Oconee Nuclear Station Regulatory Conference

Atlanta, GA
February 6, 2006

Summary of NRC Significance Determination Process Issue

TORMIS Missile Zones

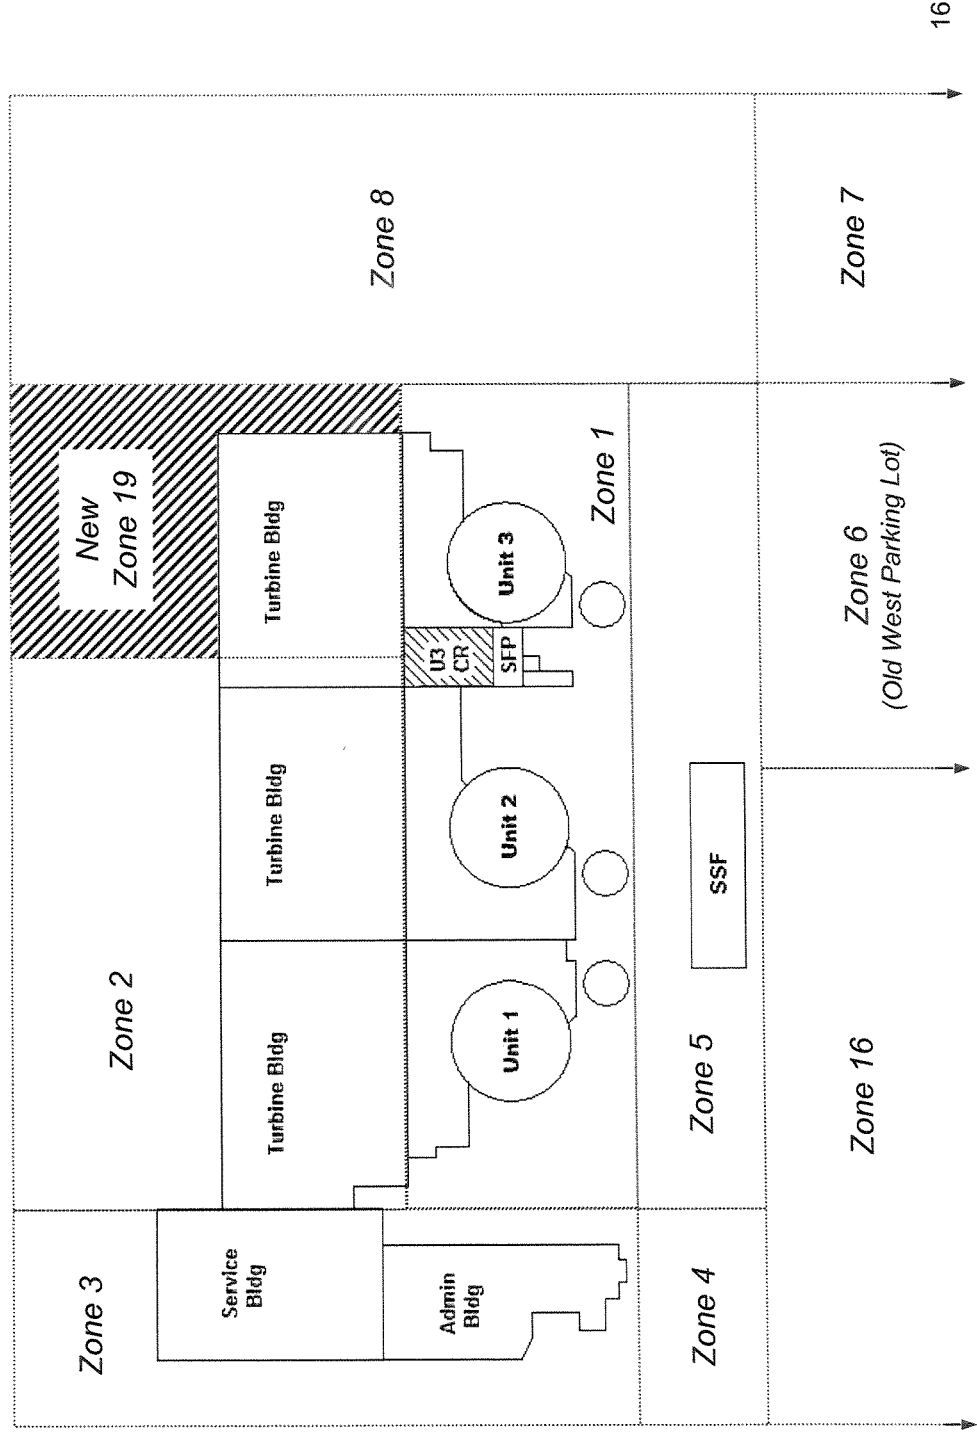
- NRC: Inspectors estimated actual missile count to be 10 to 20 times higher than assumed in the TORMIS model, and would increase the likelihood of missiles striking the wall.
- Duke Clarification:
 - ▲ Materials observed in November 2003 were located at southeast corner of Turbine Building (away from the Unit 3 control room north wall)
 - ▲ Materials observed were used to support outage activities and not present continuously through the year

- TORMIS sensitivity case
 - Increased inventory observed by inspectors was modeled in new "Zone 19".
 - Sensitivity case intended to represent "bounding" case analysis.
 - ✦ Approximately 50 times base in same area (versus inspector's estimate of 10–20 times)
 - ✦ Other potential storage/staging areas were increased by similar amount (Zones 6 & 8).

Location	Base Case	Bounding Case	Change
Zone 6	1038	15,600	15 X
Zone 8	333	16,650	50 X
Zone 19	-	14,500	50 X Zone 2
All Zones	33,434	78,813	2.36 X
